**REPLACES:** Please discard bulletin MC25-11 dated December 12, 2025. See revisions on pages 12 & 14.

**TITLE: 2024 ~ 2026 ZX636J/K Crankshaft Bearing Seizure (REVISED 1/8/2026)**

## RECALL

Inspection Item #3

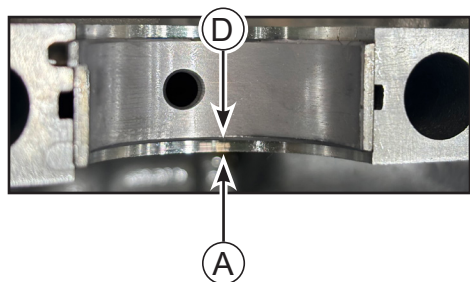
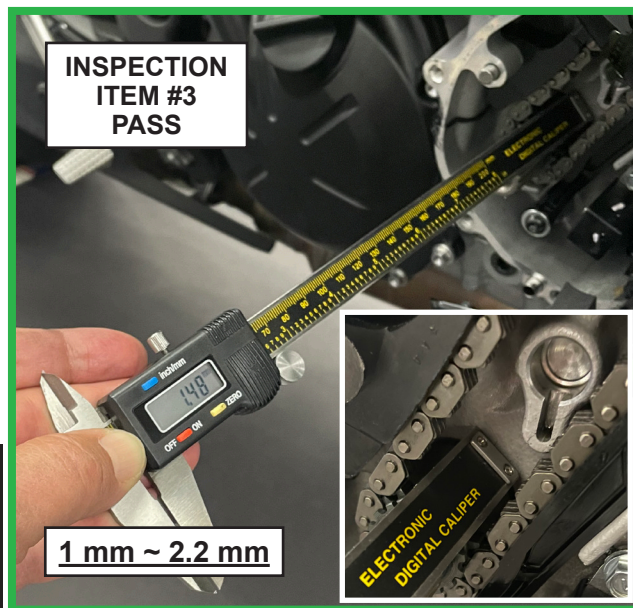
3. The upper crankcase bearing material [A] is 1 mm ~ 2.2 mm below crankcase surface [D].

REVISED

REVISED

**FAILED INSPECTION - ANY ONE OF THESE CONDITIONS**

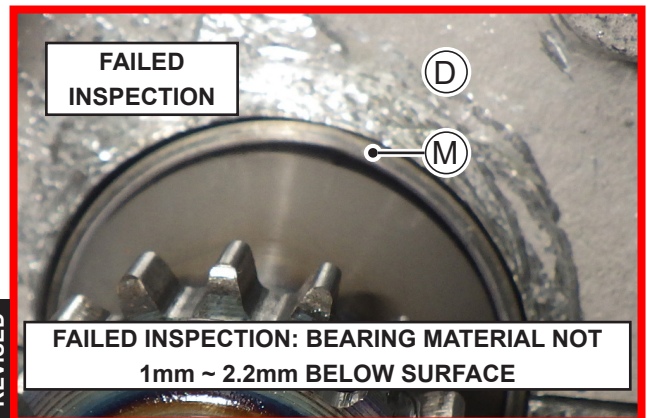
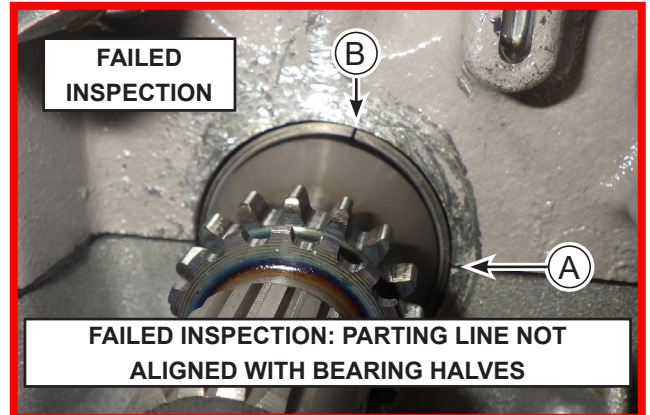
REVISED

- Crankshaft bearing material [M] **NOT** 1mm to 2.2mm **BELOW** the crankcase surface [D], migrating outward. (Applies to upper or lower bearing half.)

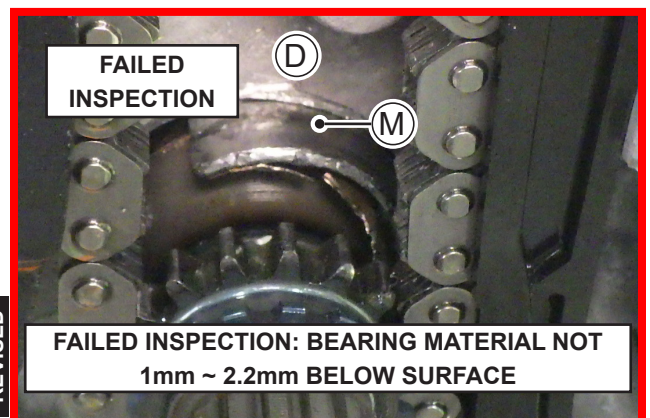
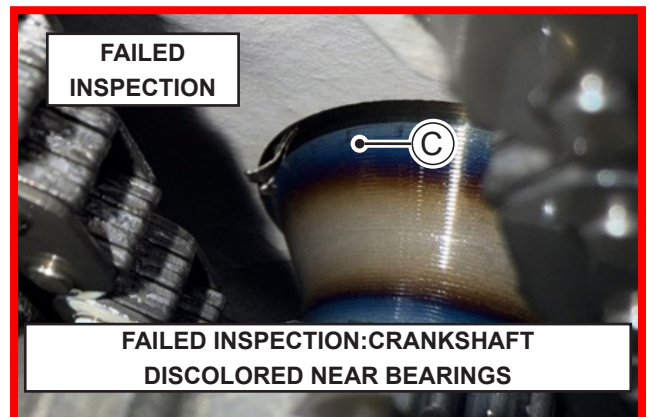
- ANY** crankshaft bearing material [M] protruding beyond the crankcase surface [D].

REVISED

REVISED
